Subject: Crazy Horse Switching Station – Approval of Minor Project Modifications #1-4

**To:** Andrew Barnsdale, CPUC  
**From:** Jeff Smith  
**Date:** August 16, 2012  
**Subject:** Crazy Horse – Analysis of PG&E Minor Project Modifications #1-4

**Re: Crazy Horse Canyon Switching Station Project – Minor Project Modifications**

**Proposed Switching Station  
Tree Removal Modification**  
Crazy Horse Canyon Switching Station

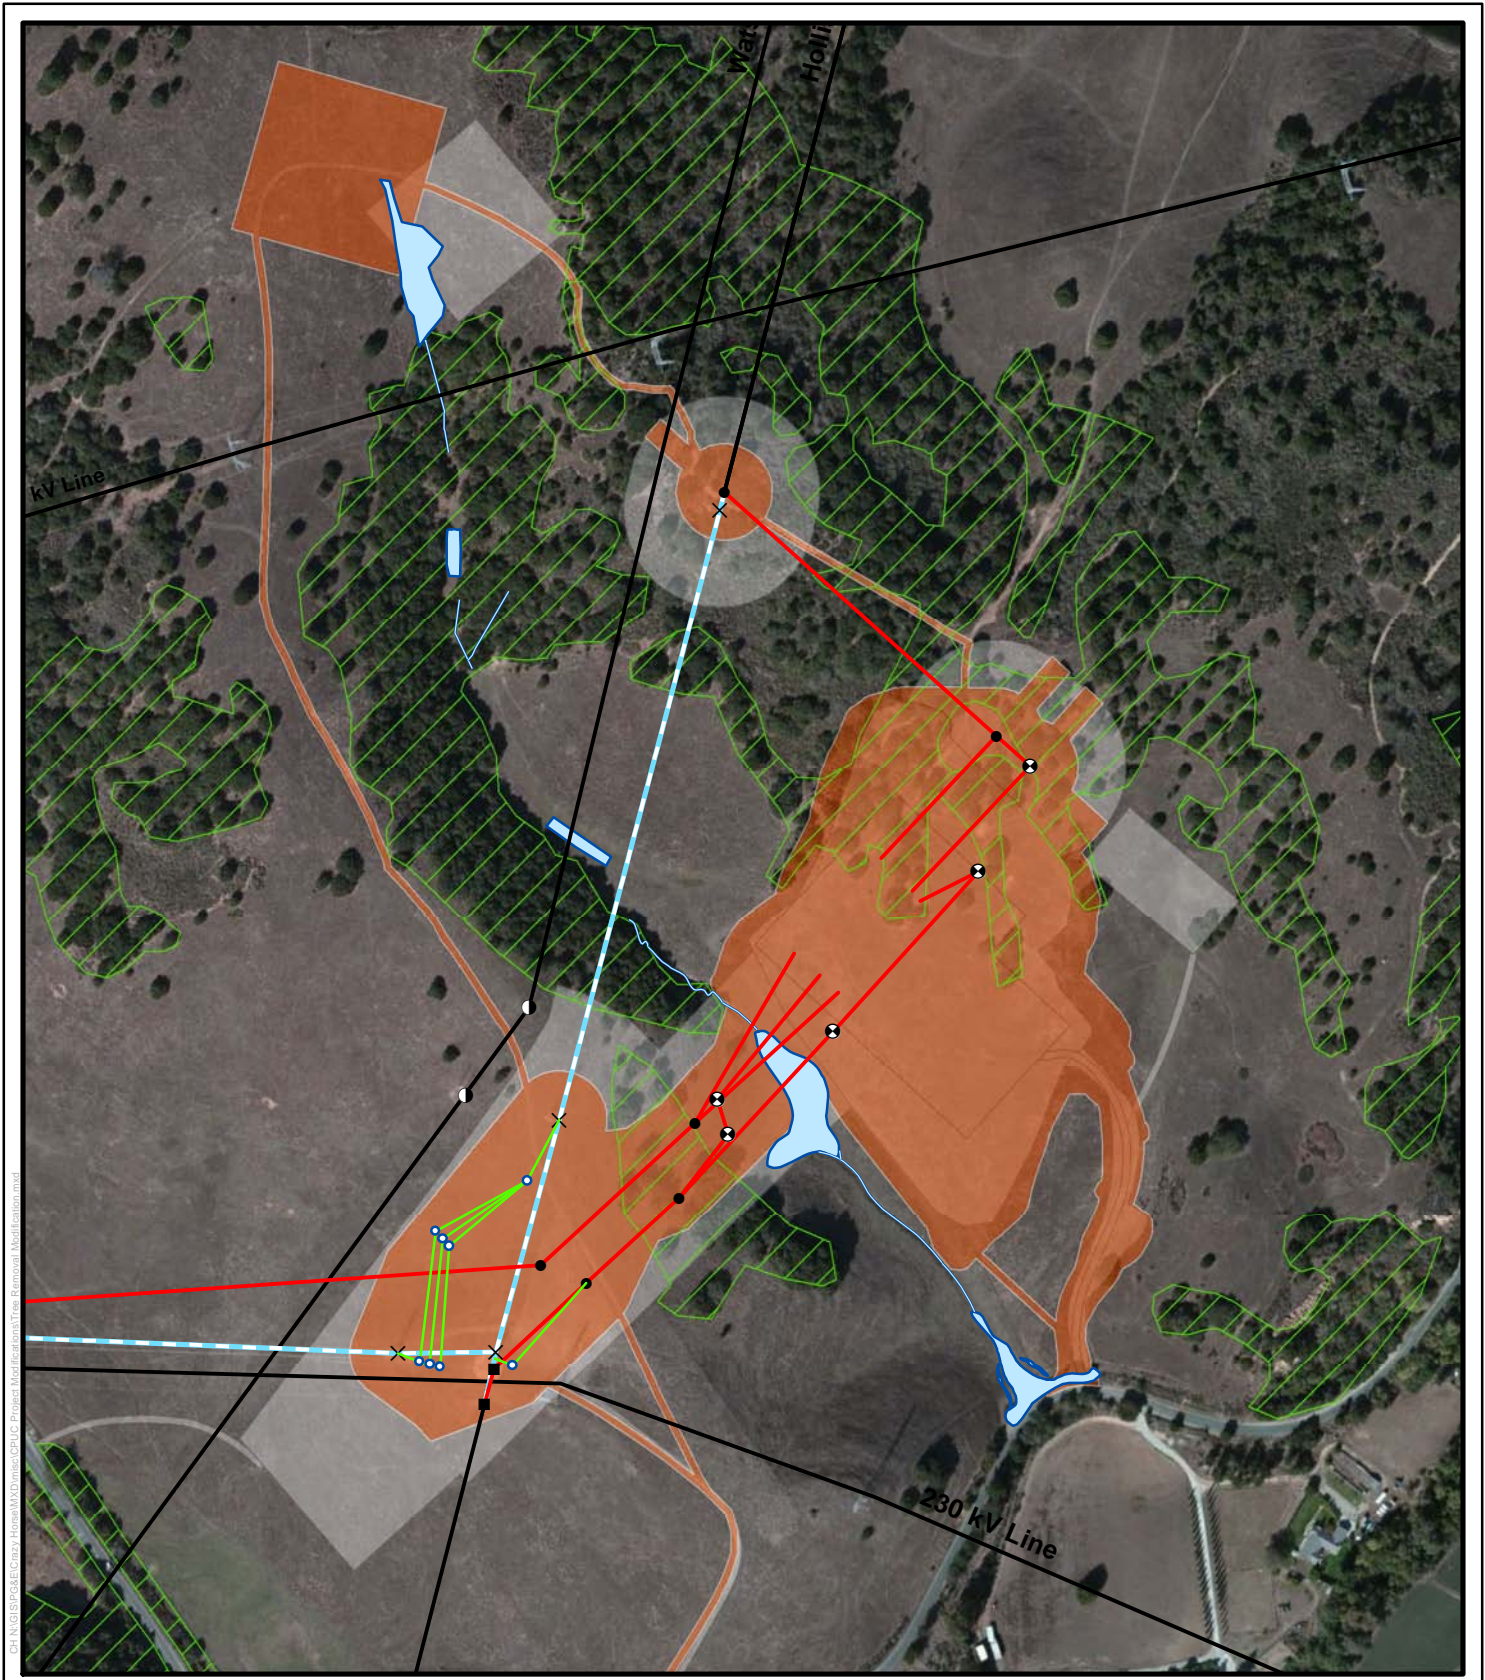
Following this submission, it was determined that additional temporary workspace (16 to 30 feet in width) would be required around the edge of the cut and fill are of the switching station in order to install the drainage system (see Modification Request No. 2) and that the trees within this additional temporary workspace will need to be removed. HortScience performed a survey on May 25, 2012, and 24 trees were identified within 30 feet of the cut and fill boundary (note - the survey performed was a width of 50 feet). All of these trees recorded by the surveys conducted by HortScience were Coast live oak.

On June 6, 2012, a field meeting was conducted with PG&E Construction Managers to confirm if workspaces containing trees could be reduced, and which individual trees would need to be removed (as opposed to pruned) within the temporary workspaces of the new towers and poles. Based on the results of the surveys and the field meeting, it was identified that approximately 127 trees will be directly impacted by the grading, including 122 for the switching facility (of which 24 are within an added 30 feet of temporary workspace) and 5 for the new access road, six of which qualify as Landmark. In addition, approximately 75 trees will need to be removed from temporary workspaces to accommodate proposed new towers or poles (12 of which are in the shared workspace with the Hollister Project at Tower 0/4). Where possible within the temporary workspaces, trees will be avoided or pruned, instead of removed. The total acreage of oak woodland to be cut is 4.95 acres.

When considering this discrepancy in the number of trees to be removed in terms of acreage of oak woodland being cut, the modified workspace results in less oak woodland being cut (4.95 acres) than that considered in the PEA and IS/MND (6.25 acres), a reduction of 1.3 acres.

The number of trees to be removed documented in the PEA was estimated by counting crowns on an aerial, which did not capture smaller trees that were beneath the crowns of larger trees. The discrepancy was confirmed when the oak survey was conducted in December 2011. Based on the modified workspace, the total acreage of oak woodland being cut will be less than that specified in the PEA/MND.

See modified workspace/coast live oak woodland on the attached map.
